3 x 7 BRACKET #M29320

305 US 131 SOUTH (269) 483-9634
 WHITE PIGEON, MI 49099 483-9636 (FAX)
 PART: 3 x 7 BRACKET (std holes)
 ASSEMBLY: FORD CLASS C FRONT
 DRWG BY: B. SLACK > DATE: 8/20/12
 TOLERANCES: .XX± .02 .XX± .010 .XXX± .005
 MAT'L: 1/4" FLAT ASTM A36

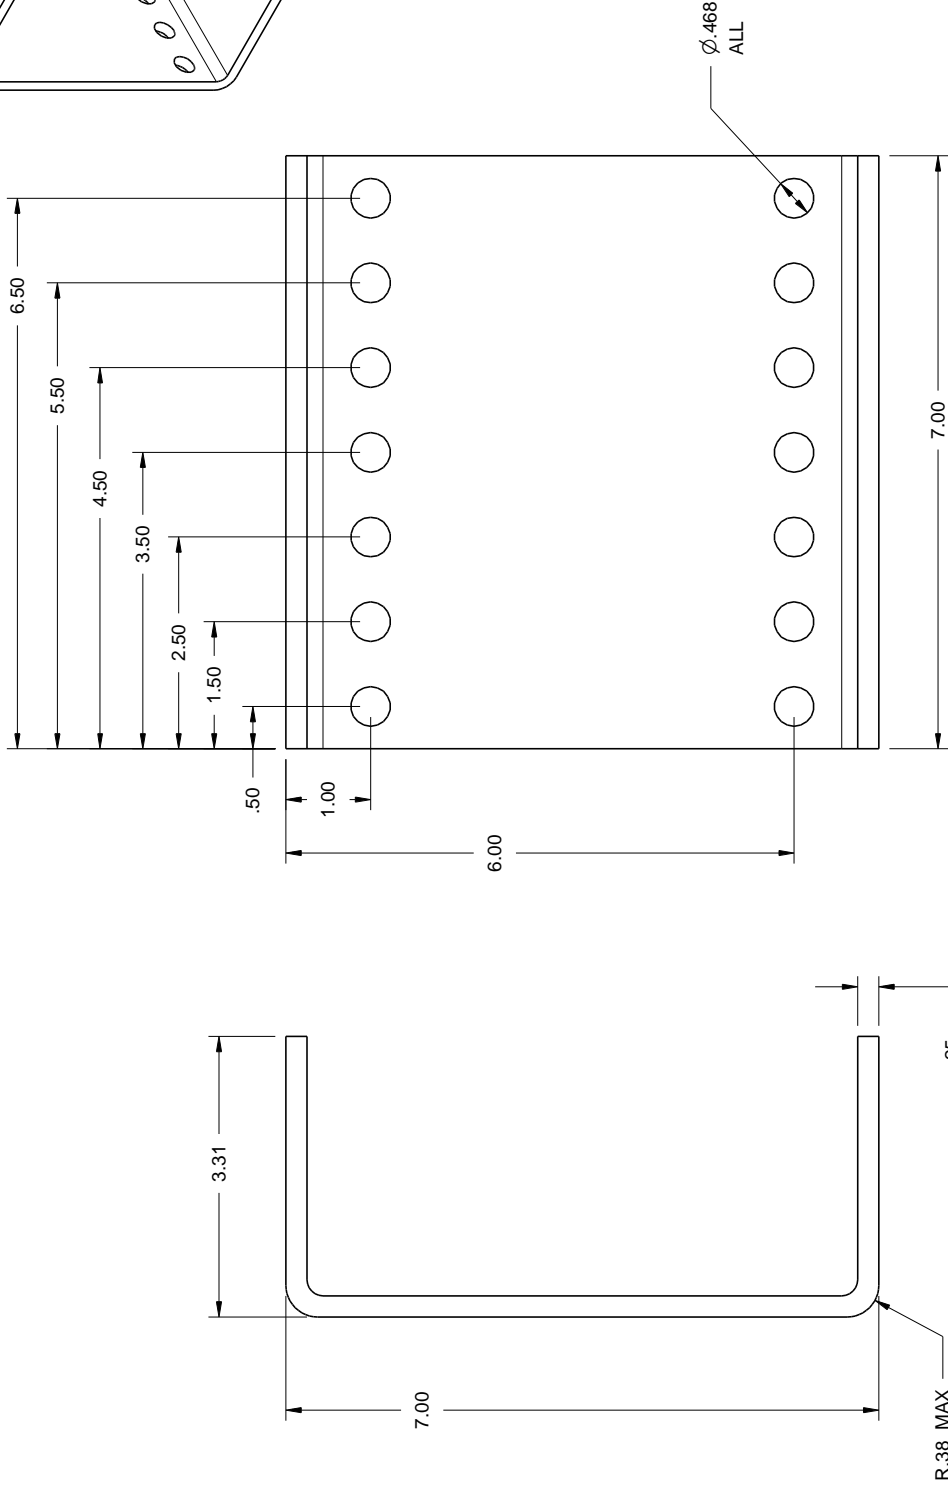
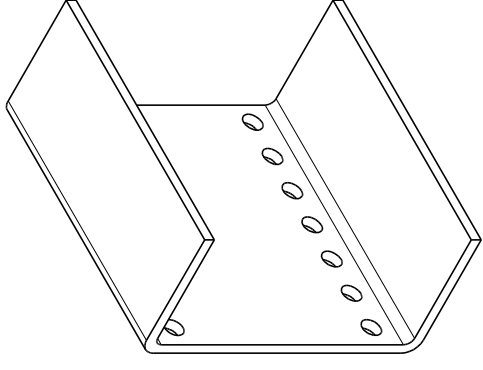
REVISION 8/31/12:
 INCREASED DEPTH OF BRACKET FROM 3" TO 3 5/16" FOR ADDITIONAL CLEARANCE ON CERTAIN FRAMES.
 REVISION 8/20/12:
 MADE HOLES EVERY 1" FOR ADDED VERSATILITY.
 STANDARD HOLE SIZE (.468") VS. LARGER HOLES FOR WELD NUTS (.671")
